Access Compliance Report

Public Rights-of-Way

(Pedestrian Signals)

Intersection ID: N/A	Main Street:	Cross Street: N/A	Location: N/A
ADA ID: 914A67C730E2	Signal Type: One Push Button-Non APS	Overall Compliance: No	Severity Score: BTN 1: N/A BTN 2: N/A No BTN: N/A
Codes/Mitigation Info/Possible Solution		Field Measurements/Component Compliance

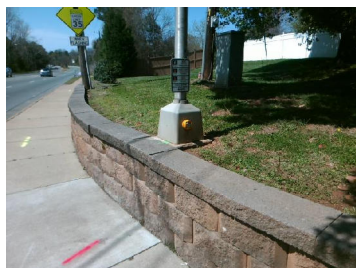
PROW/ADA: R410.6, TMUTCD 4e.08, R404.2, R404.3, R404.7.3, R404.7.2

N/A	B 1 Clear Xing Direction?	Yes	N/A	B 2 Clear Xing Direction?	N/A
	B 1 Crossing Direction	To SE		B 2 Crossing Direction	N/A
Yes	B 1 DistanceTo XWalk (in)	30.0	N/A	B 2 DistanceTo XWalk (in)	N/A
No	B 1 DistanceTo Curb (in)	85.0	N/A	B 2 DistanceTo Curb (in)	N/A
Yes	B 1 Diameter (in)	2.0	N/A	B 2 Diameter (in)	N/A

Possible Solutions: Replace Signal Push Button With APS Button on New Post. Remove & Replace Sign.
